Crosley Corp.	
	Model: 5V2	Chassis:	Year: Pre October 1936
	Power:	Circuit:	IF:
	Tubes:	•	<u> </u>
	Bands:		
		Resources	
Riders Volume 6	- CROSLEY 6-6		
Riders Volume 7	- CHANGES 7-15

©John F. Rider, Publisher

Changes to be made in Silvertone Models 1720, etc.

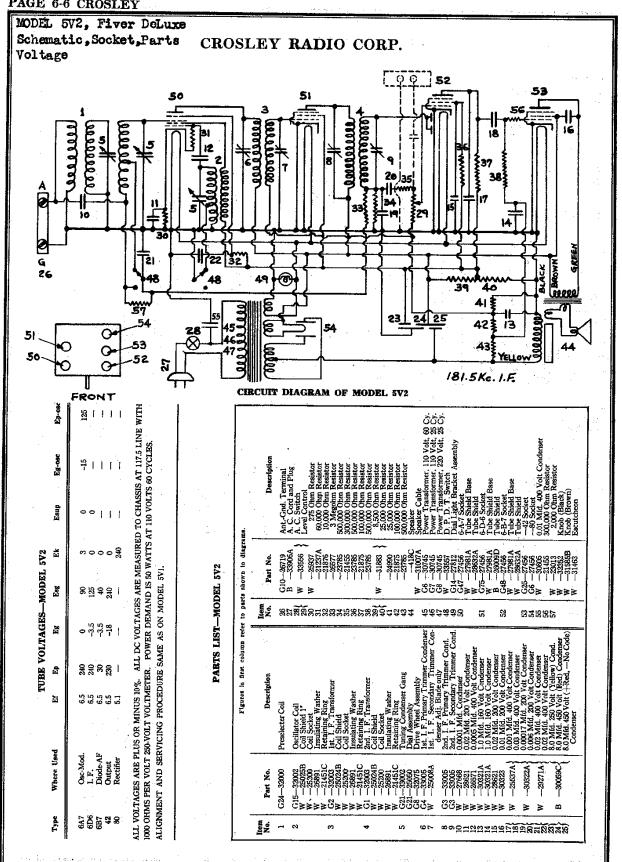
Any trouble due to hum in these models can be eliminated by performing the following operations, the purpose being to add an additional section of filtering to the power supply.

Enlarge the hole in the chassis near the power transformer to about 0.25 inch diameter, as indicated in the illustration

Make the wiring changes indicated in the illustration. The dotted lines represent the original wiring, which is to be changed and the solid lines show the new connections. Note that a new part, a 2-mf., 440-volt, dry electrolytic condenser, Part No. R11114, is added.
